MOD2024/0252

S4.56 SUMMARY OF CHANGES:

Project Name
1955 Pittwater Rd., Bayview

Drawing Title
Site Plan

DA.205

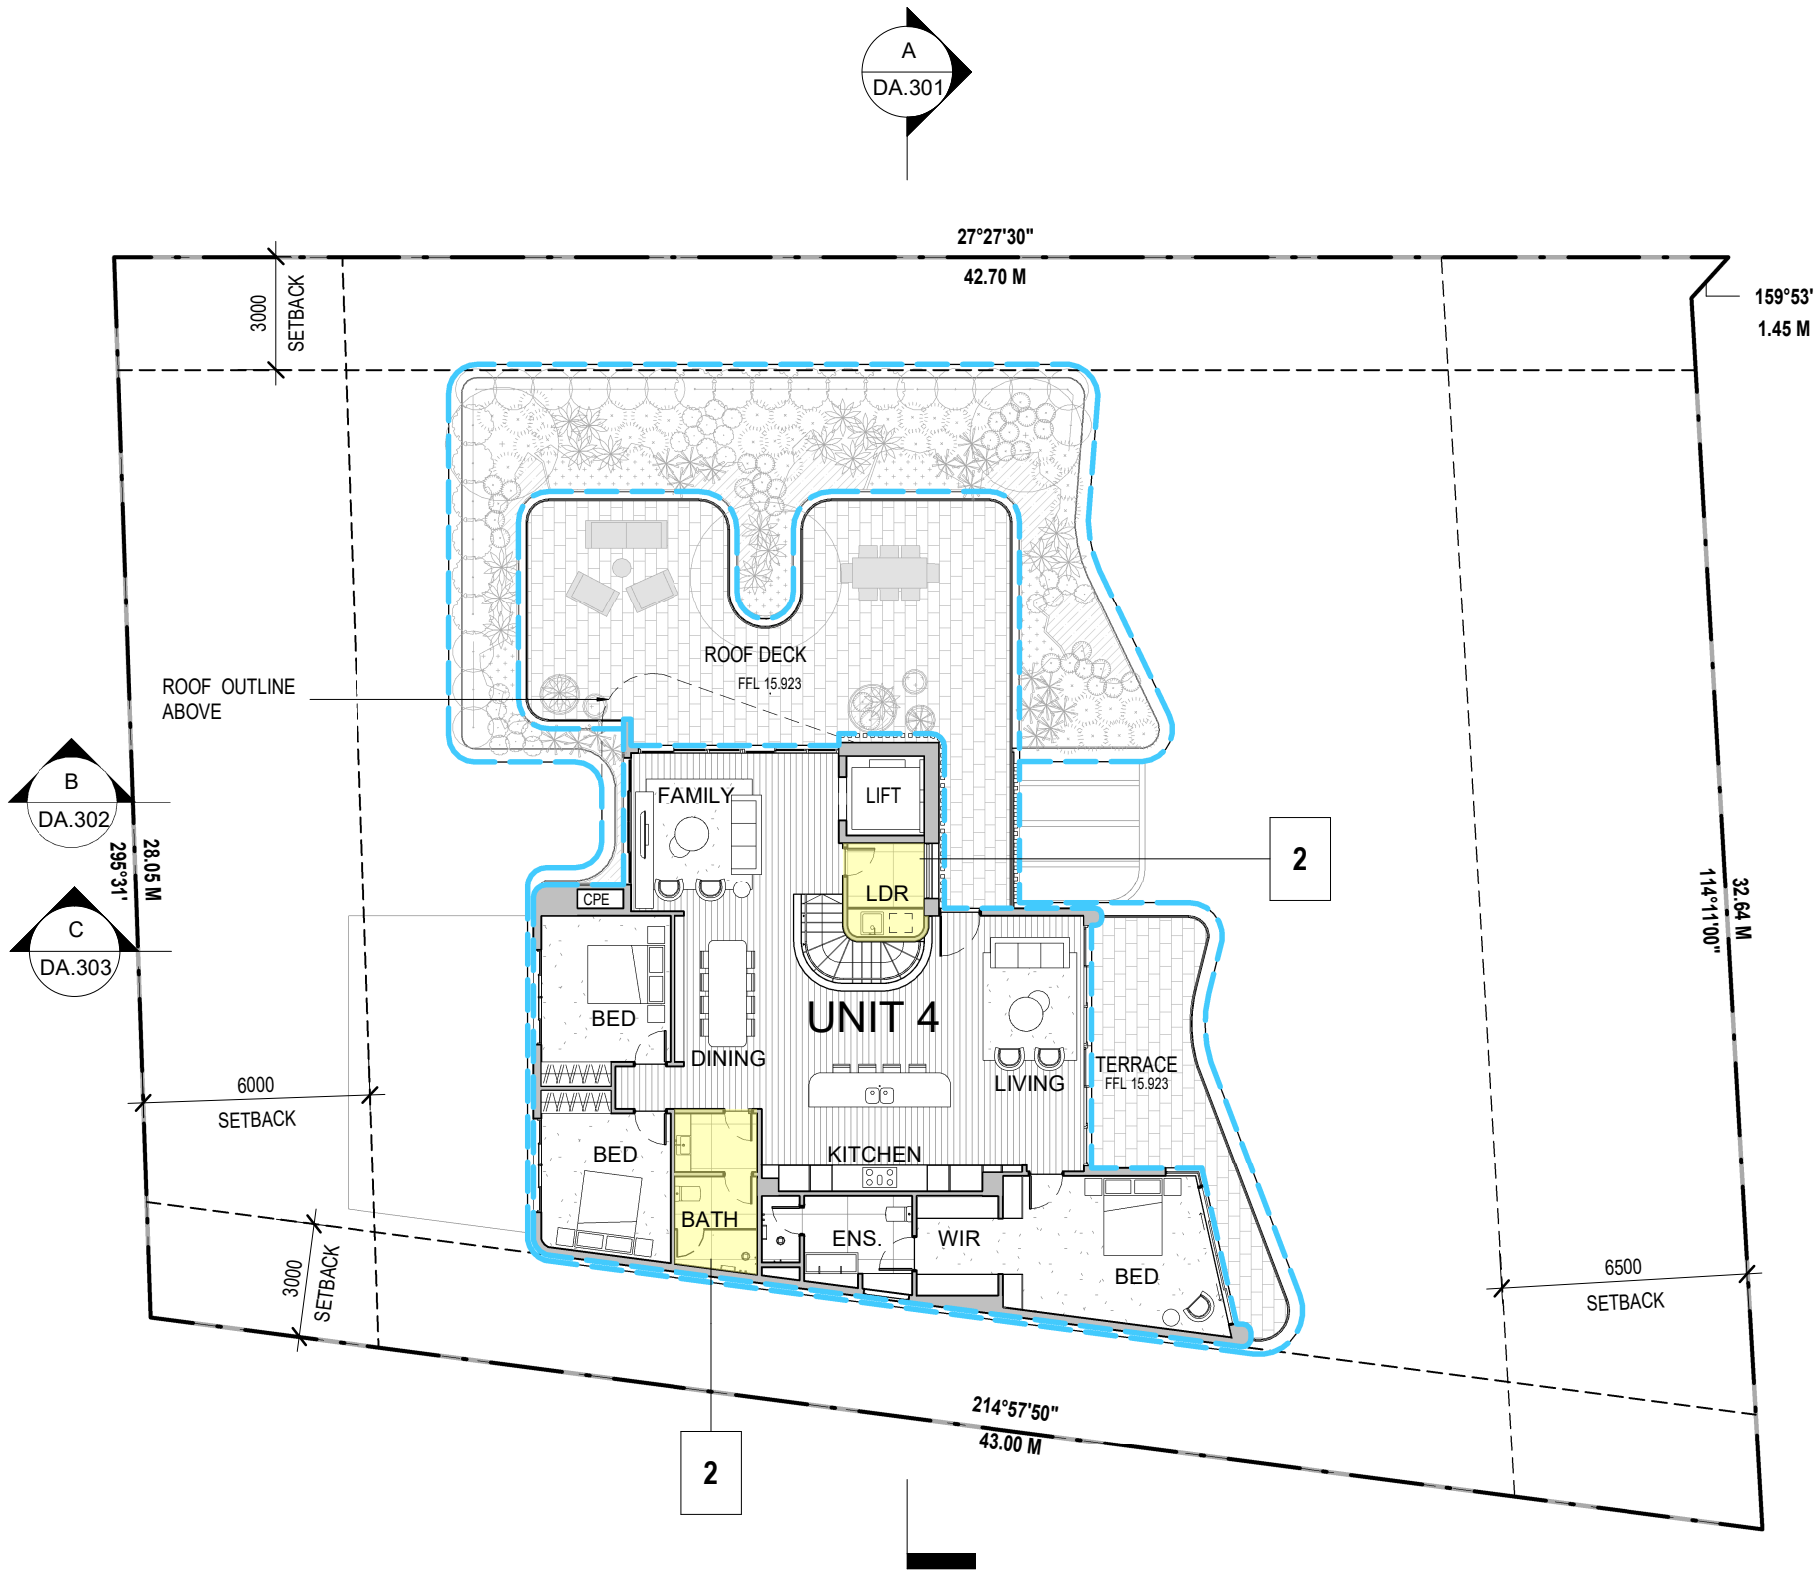
- 1. UNIT 1 layout re-configuration to improve amenity
- 2. UNIT 4 relocation of Laundry Room
- 3. New window to provide ventilation
- 4. Glazing adjustment for better alignment

Drawing no:
DA.301

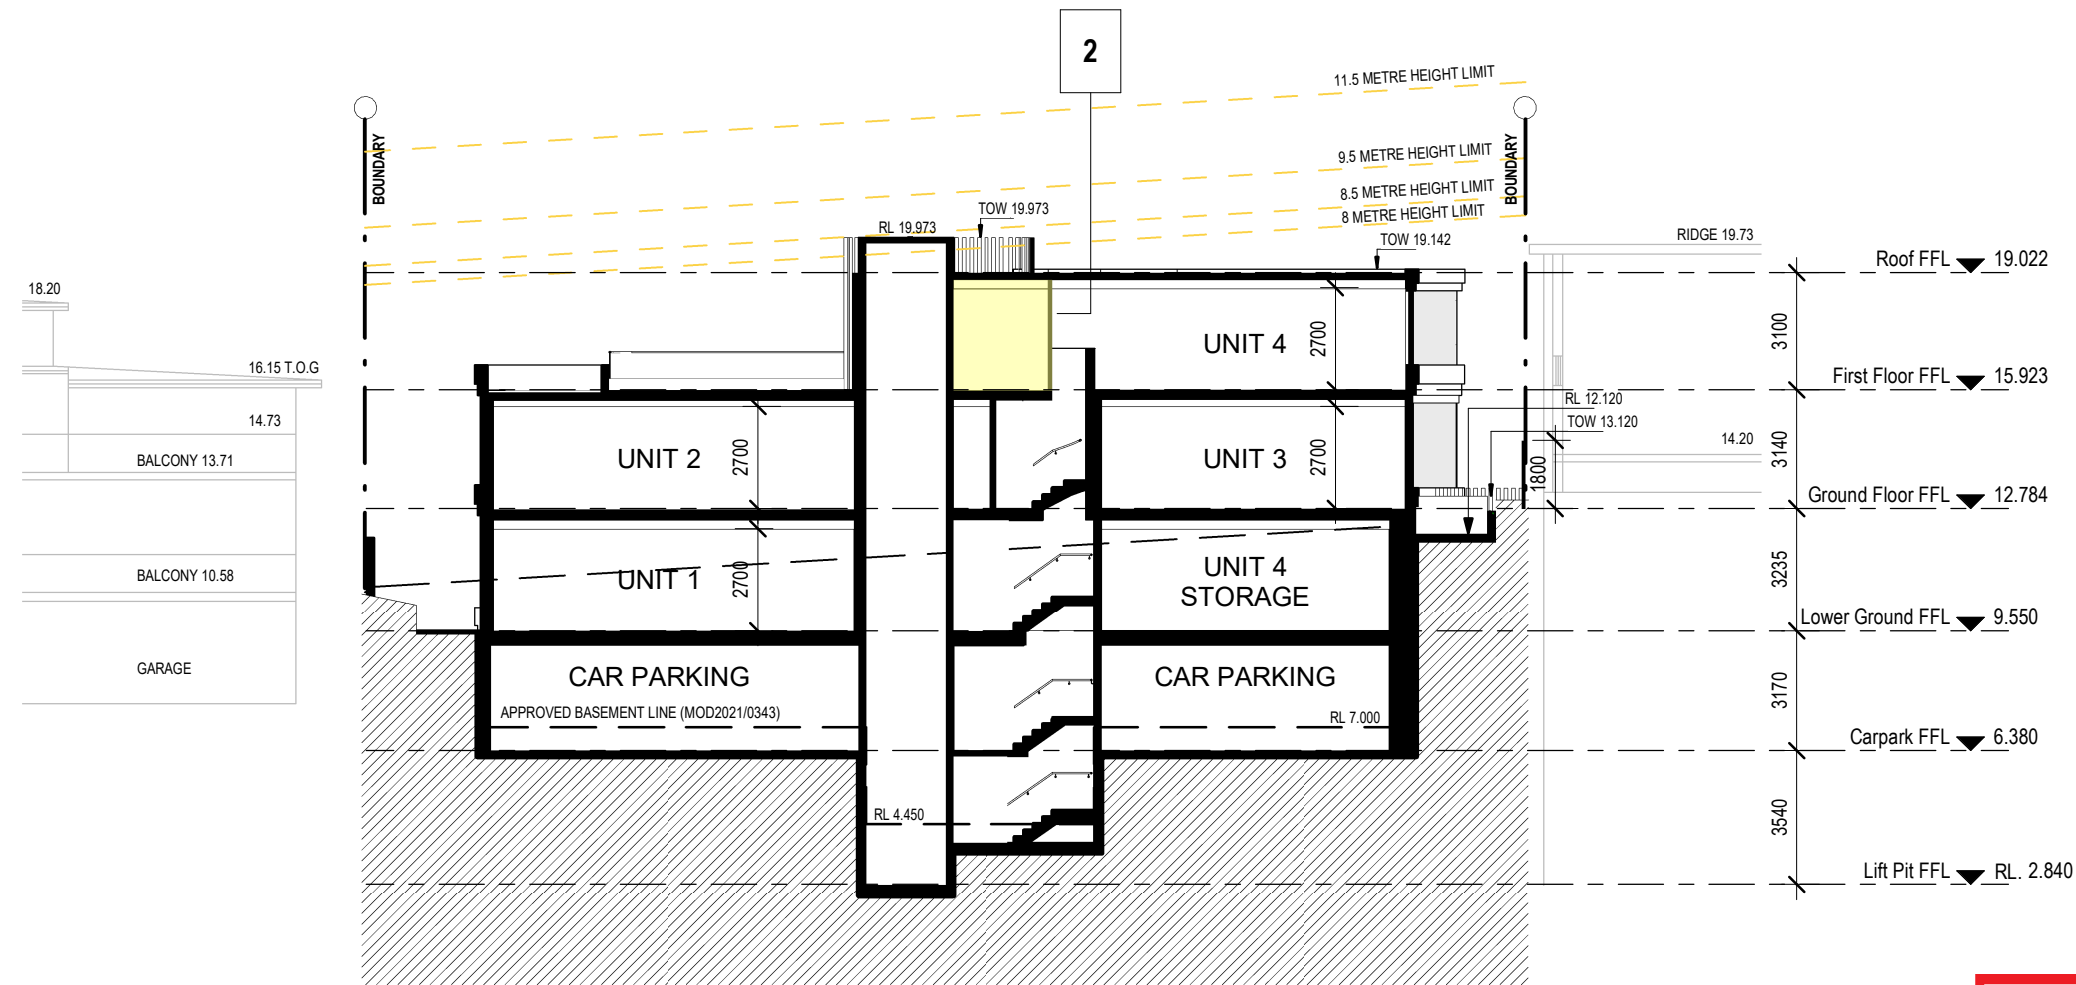
- 1. UNIT 1 layout re-configuration to improve amenity
- 2. UNIT 4 relocation of Laundry Room
- 3. New window to provide ventilation
- 4. Glazing adjustment for better alignment

SCALE 1 : 200 @ A3 Drawing no: DA.302

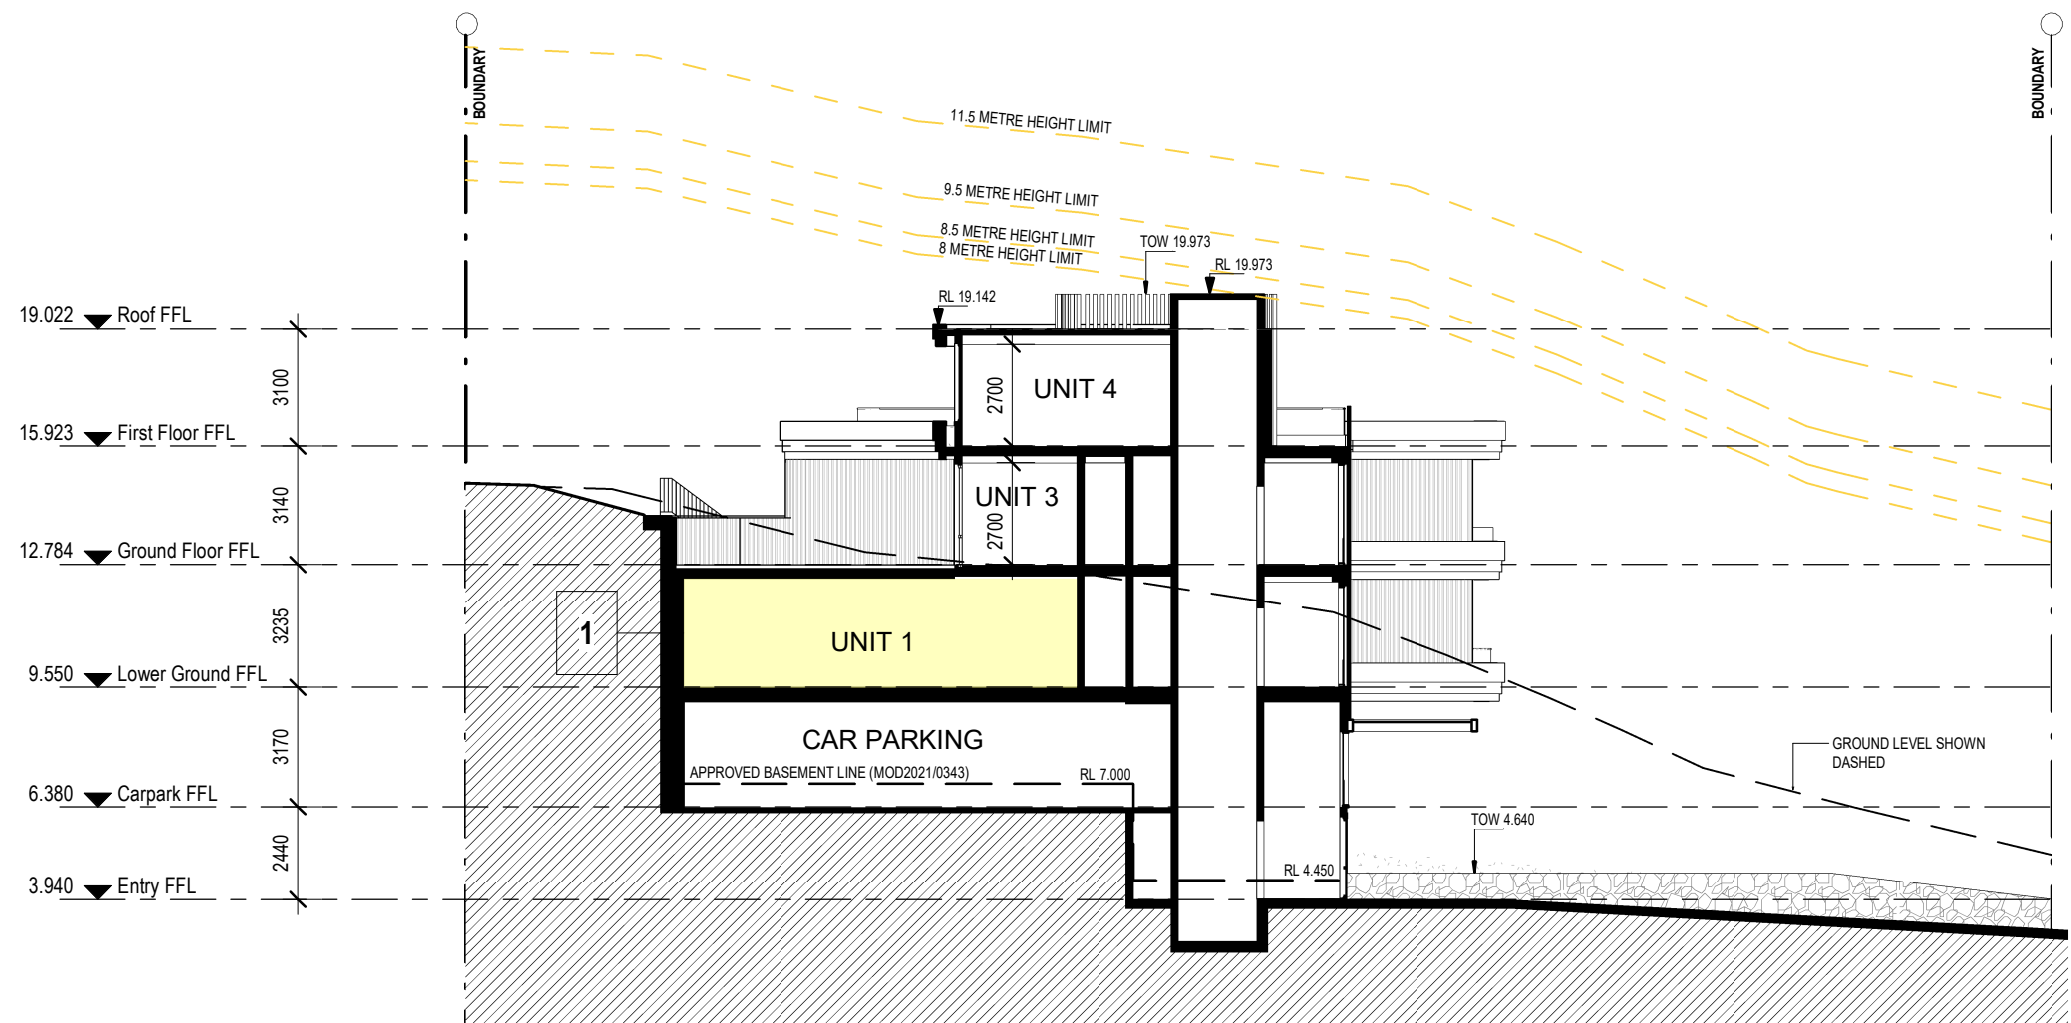
- 1. UNIT 1 layout re-configuration to improve amenity
- 2. UNIT 4 relocation of Laundry Room
- 3. New window to provide ventilation
- 4. Glazing adjustment for better alignment

SCALE 1 : 200 @ A3 Drawing no: DA.303

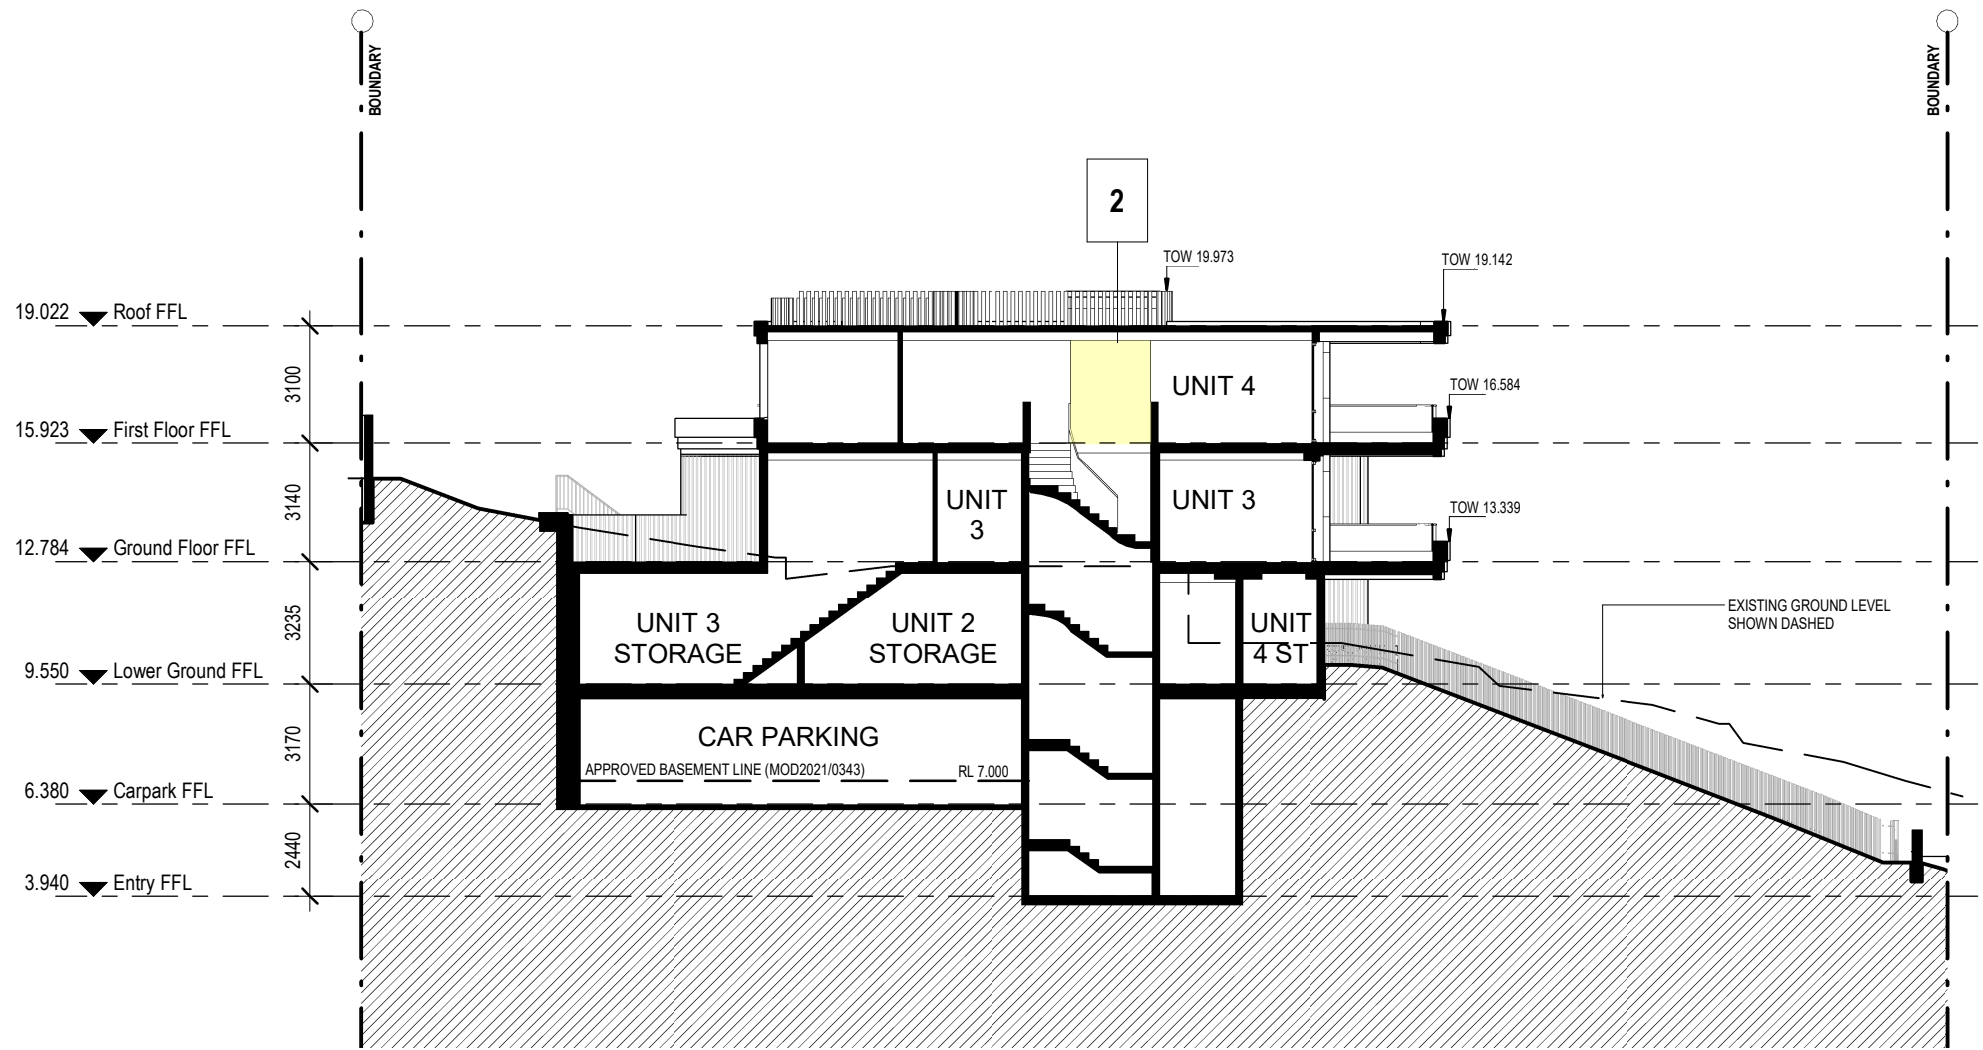
- 1. UNIT 1 layout re-configuration to improve amenity
- 2. UNIT 4 relocation of Laundry Room
- 3. New window to provide ventilation
- 4. Glazing adjustment for better alignment
